MEMORANDUM

Subject: Dunwoody Village Master Plan Update

Updated Street Improvements

Dunwoody Village Master Plan Update

Mount Vernon Road Proposed Improvements

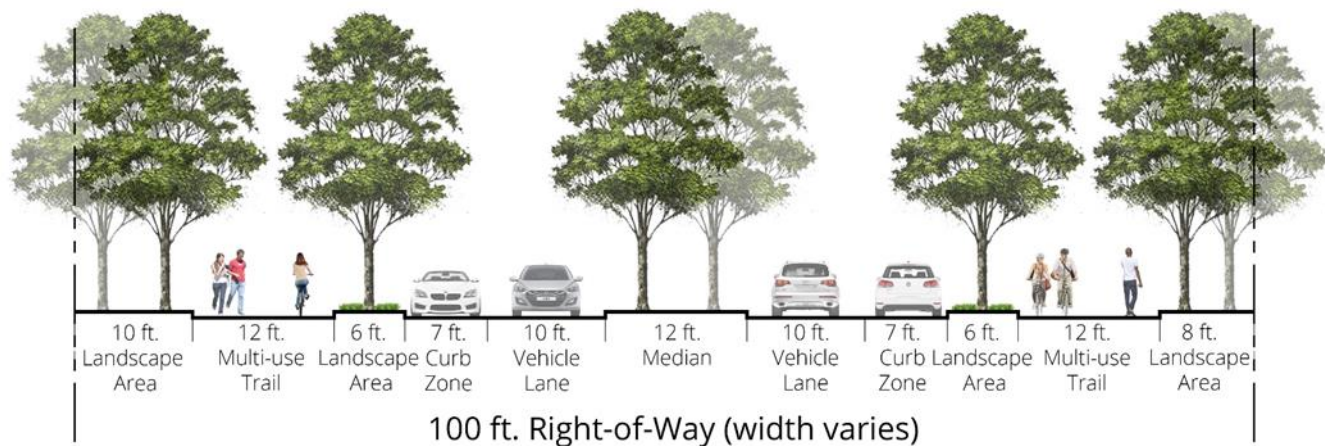
The following replaces the second column on page 44:

Multi-modal improvements should be undertaken for Mount Vernon Road. The aspirational vision for Mount Vernon Road based on typical existing right-of-way is shown in the following section:

The above vision also assumes the following:

- A speed limit reduction to 25 miles per hour
- Street trees, pedestrian lighting, and roadway lighting
- Intersection enhancements including new mast arm traffic signals, pedestrian signals, high visibility crosswalks, and ADA Ramp improvements where necessary
- A design that minimizes the length of crosswalks to shortest distance necessary
- Removal of overhead utility lines and replace with underground utility lines
- Access management considerations to reduce and limit curb cuts and potential conflict areas along the corridor

Chamblee Dunwoody Road Proposed Improvements

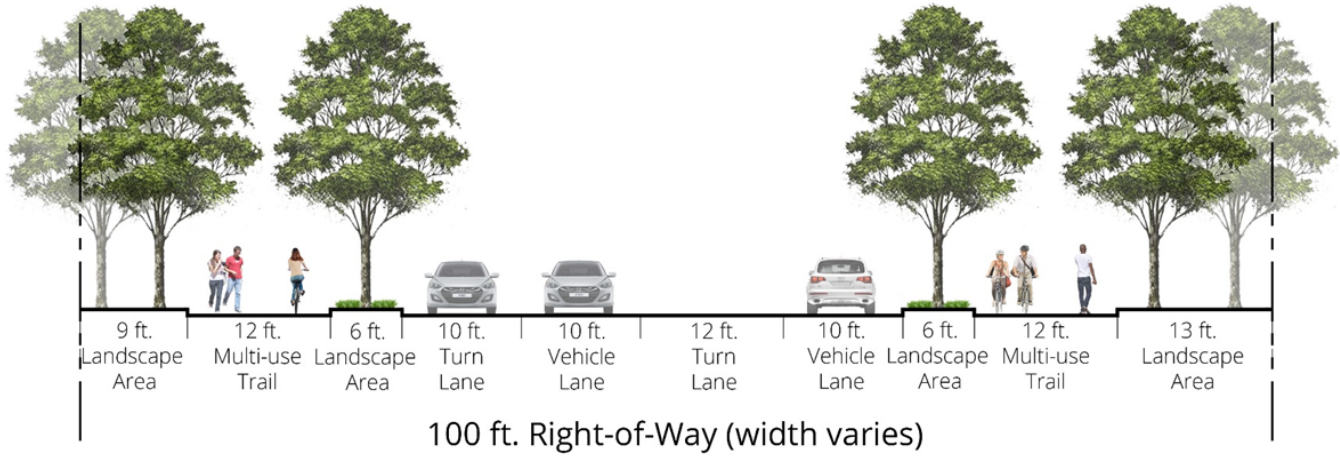
The following replaces the third column on page 43 and the first column on page 44:

Multi-modal improvements should be undertaken for Chamblee Dunwoody Road in one or more phases. The aspirational vision for Chamblee Dunwoody Road based on typical existing right-of-way is shown in the following section:

The above vision also assumes the following:

- A speed limit reduction to 25 miles per hour
- Street trees, pedestrian lighting, and roadway lighting
- Intersection enhancements including new mast arm traffic signals, pedestrian signals, high visibility crosswalks, and ADA Ramp improvements where necessary
- A design that minimizes the length of crosswalks to shortest distance necessary
- Removal of overhead utility lines and replace with underground utility lines
- Access management considerations to reduce and limit curb cuts and potential conflict areas along the corridor
